Access Compliance Report Public Rights-of-Way (Curb Ramps)

Intersection ID: 19931 Main Street: CARNEGIE BV **Cross Street: ASSEMBLY ST** Location: NE Initial Pass/Fail: Fail **Overall Compliance: No** 10 **ADA ID: 45DFF1DEEAA8** Ramp Type: Perp **Severity Score:**

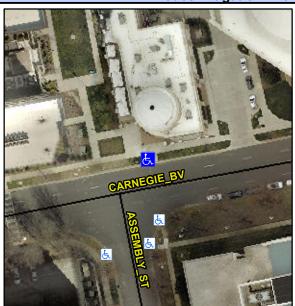
Possible Solutions:	Compli	ance	Description
Remove & Replace Entire Ramp.	N/A	Ramp	Length (in)
	No	Ramp	Width (in)
	N/A	Flare	Type LT
	N/A	Flare	Slope LT (%)
	N/A	Flare	Traversable LT
	N/A	Landi	ng Length (in)
Surveyor Notes:	N/A	Landi	ng Width (in)
N/A	N/A	Landi	ng Slope (%)
	N/A	Landi	ng X Slope (%
	N/A	Landi	ng Curb? (Y/N
	N/A	Share	ed Landing?
PROW/ADA:	N/A	Gutte	er Ponding?
Not Found, R304.5.1, R304.5.3	N/A	Gutte	er Lip Ht (in)
· · ·	N/A	Paint	ed X Walk1?
		X Wa	lk 1 Direction
	N/A	X Wa	lk 1 Width (in)
		X Wa	lk 1 Slope (%)
		X Wa	lk 1 X Slope (%
	N/A	Ramp	inside XWalk
		Road	Slope (%)
		Doca	V Clana (0/.)
